Montana Department of Transportation

To: Lesly Tribelhorn, P.E. Highways Engineer
From: Damian Krings, P.E. Road Design Engineer
Date: December 19, 2018
Subject: STPS 203-1(15)4 North of Stevensville-North UPN 6138000 Work Type 140 - Reconstruction - without added capacity

Project Design Exception

STPS 203-1(15)4, North of Stevensville-North, UPN 6138000

Exhibit A (RP 4.4 to RP 5.5: Standard curves vs. proposed curves)

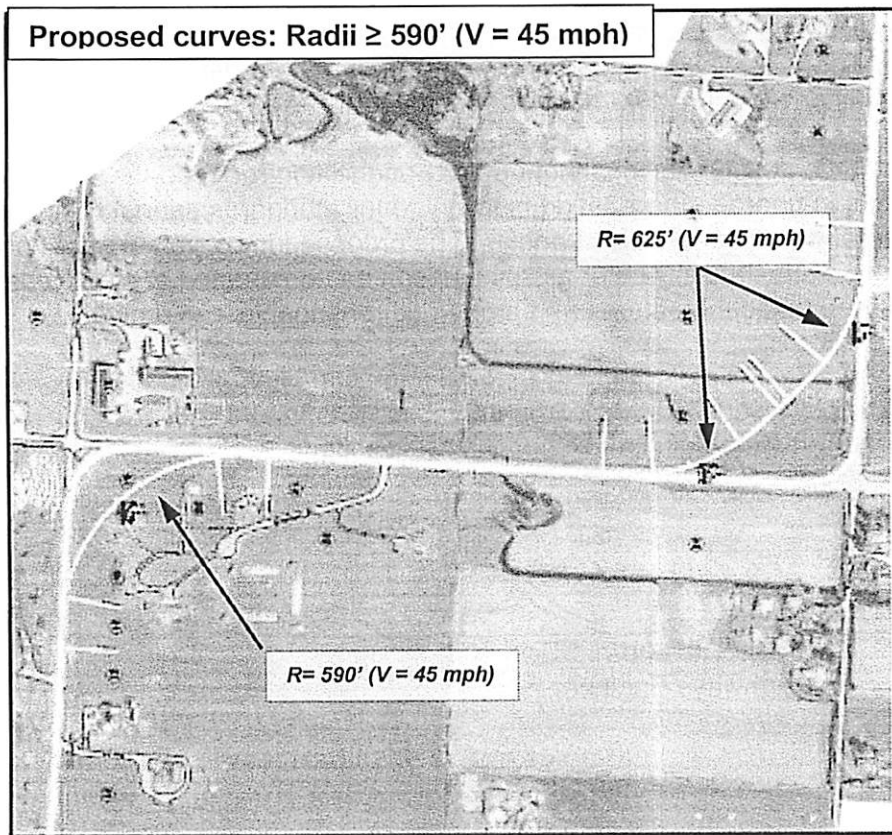
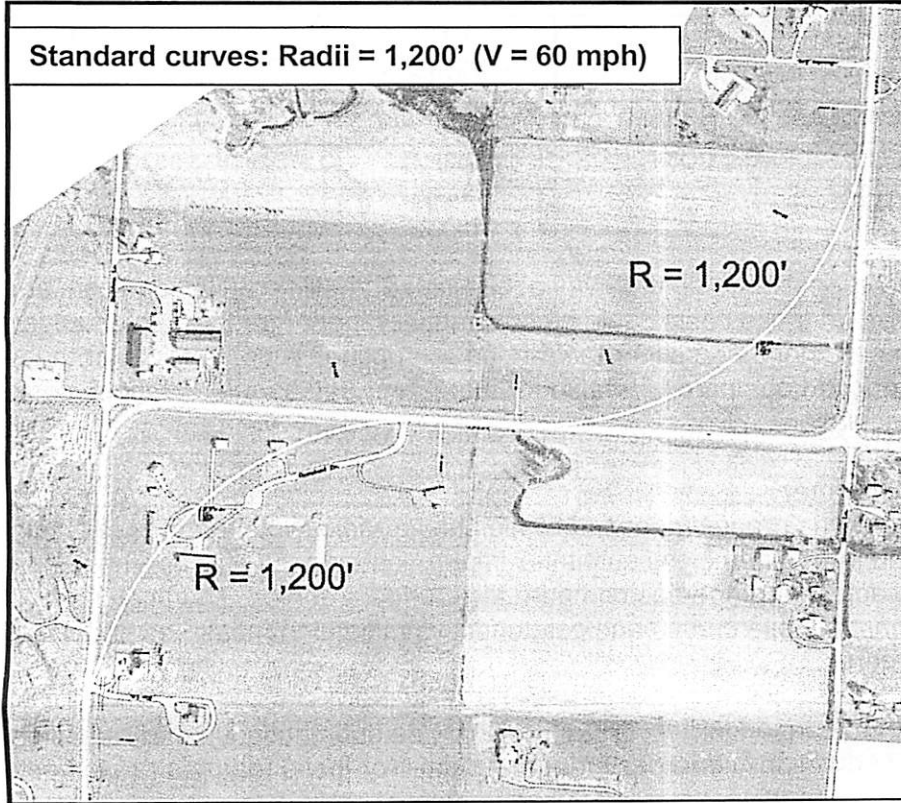
We propose to replace the 210-ft. radius simple curve right (V = 30 mph) at RP 4.6 with a 590-ft radius spiraled curve (s= 8%, V = 45 mph).

We propose to replace the 114.6-ft. radius simple curve left (V = 24 mph) with a pair of 625-ft radius spiraled curves (s= 8%, V = 45 mph) connected by a 56-ft. tangent superelevated at 2% at the Ambrose Creek Road intersection

The three curves described above are the preferred action to replace the two extremely substandard curves because they will allow operating speeds through the curves much closer to the mainline running speeds, yet will have much less impact to the adjacent agricultural and residential properties, compared to the impact of two new curves that meet the standard for minimum radius (see Exhibit A)

One alternative alignment to replace the two substandard horizontal curves is shown in Exhibit A. We do not believe we could justify the substantial impacts to at least nine parcels. Several other parcels could also be severely impacted to provide access to the new alignment. The selected alignment strikes a good balance in our need to substantially improve the safety and operation through this section with our desire to not severely impact several roadside properties. There are segments along the project where a standard 8-ft. shoulder and/or 14-ft. TWLTL could be constructed with little additional impact to roadside properties. However, to maintain consistency and not violate driver expectancy we rejected this notion.

Exhibit B (Typical Section elements): Std. 14' TWLTL vs. Proposed 12' TWLTL
Std. 8' shoulders vs. Proposed 4' shoulders
Std. flat-bottom ditch vs. Proposed v-ditch

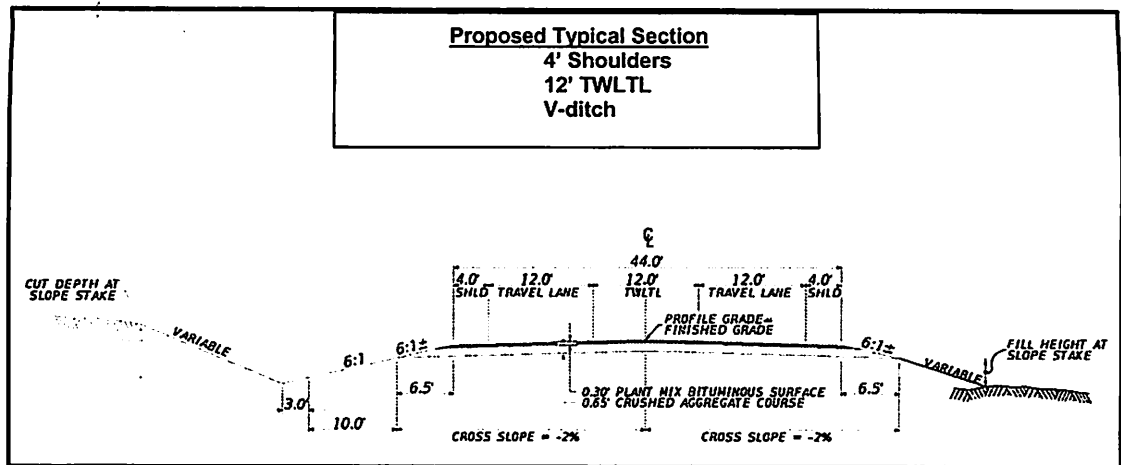
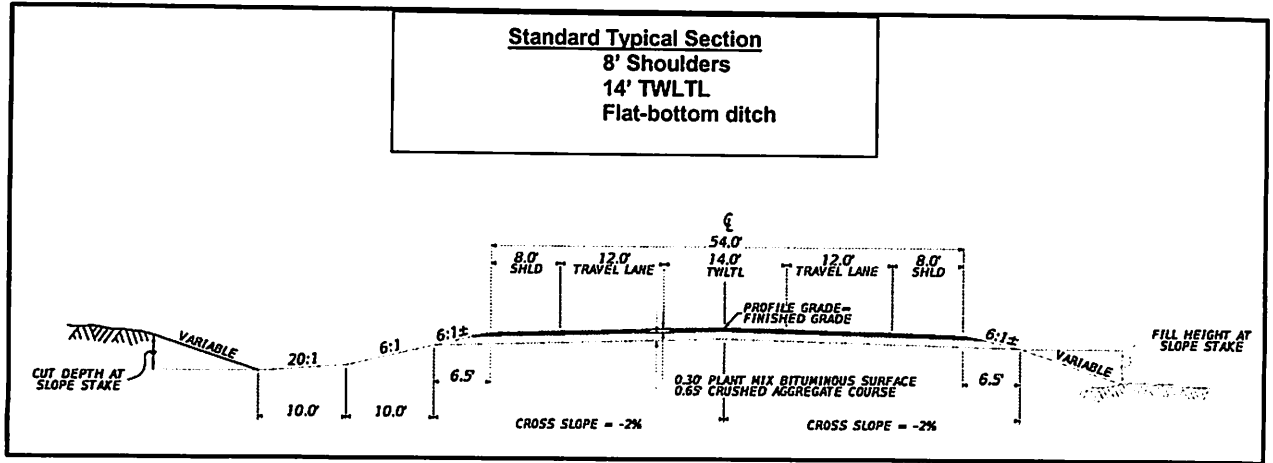
- Auxiliary lane width: We propose a TWLTL width of 12 feet to reduce the impacts of the proposed total paved width, which at 44 feet will be 10 feet wider per side than the existing paved width.

- Shoulder width: We propose a shoulder width of 4 feet along the segments where TWLTLs or dedicated left turn lanes are proposed. This includes the segments from RP 4.08 to 6.12, RP 7.11 to 9.13, and RP 9.93 to 10.15. The 4-ft. shoulder will be a substantial improvement over the existing roadway, which has no shoulders.

- Flat-bottom ditch width: We propose to reduce the flat-bottom ditch width to as little as 0 feet (i.e. a v-ditch) where doing so will reduce the right-of-way acquisition required. With a 6:1/4:1 v-ditch, the lateral extent of construction impact will be reduced by about 7 feet on a 10-ft. cut, compared to the standard flat-bottom ditch with a 4:1 backslope.

Exhibit C (Representative cross-sections)

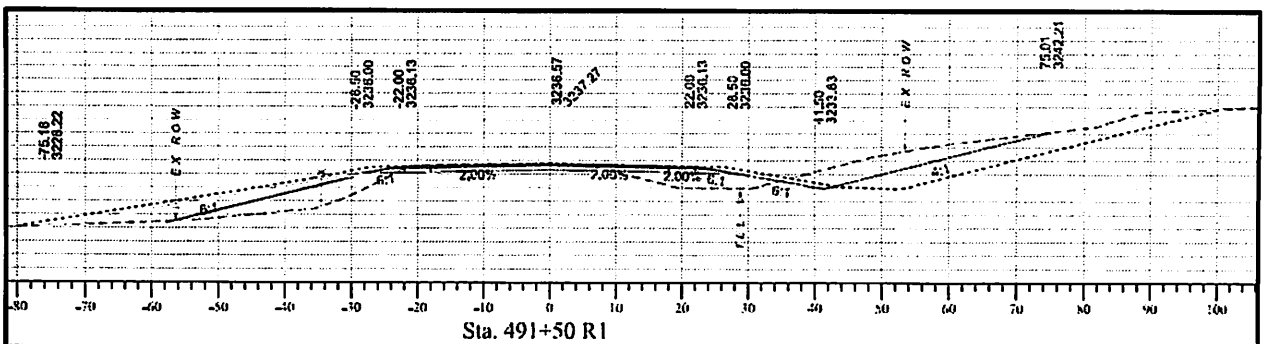
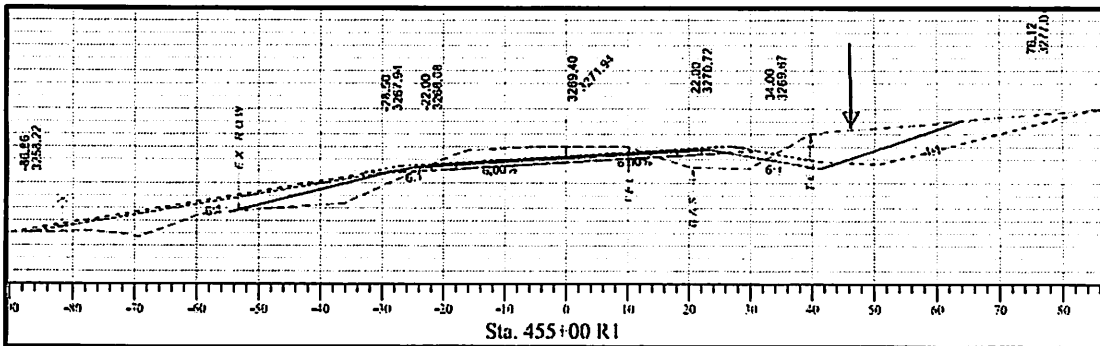
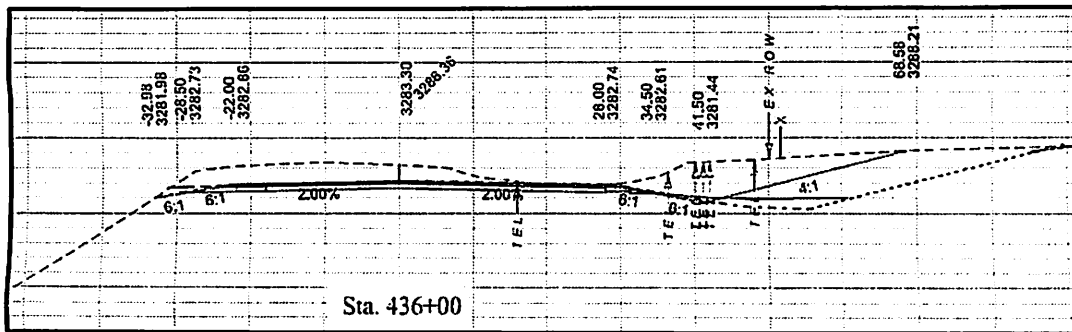
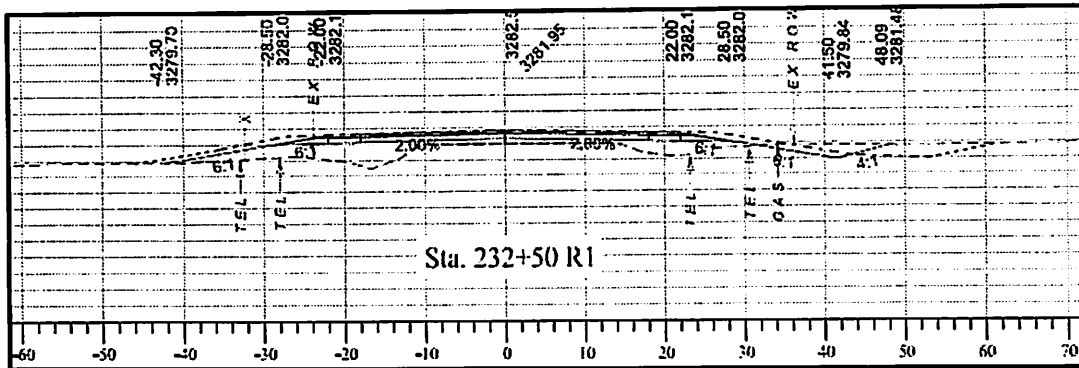
- Fill slopes: We generally propose to use steeper recoverable slopes (i.e. 4:1's) along areas where a standard 6:1 slope would require more than 30 feet of new right-of-way acquisition. There will probably also be a few intermittent segments (including the historic properties, the wildlife refuge, and properties where improvements such as structures and drain fields would be impacted) where we will propose to steepen fill slopes less than 10 feet high to a 3:1.

For fills 10 to 20 feet high where the standard 4:1 slope would require more than 40 feet of new right-of-way acquisition, we propose a 3:1 slope. Again, there could be a few isolated segments where we will propose a 2:1 or flatter slopes to avoid impacting roadside improvements.
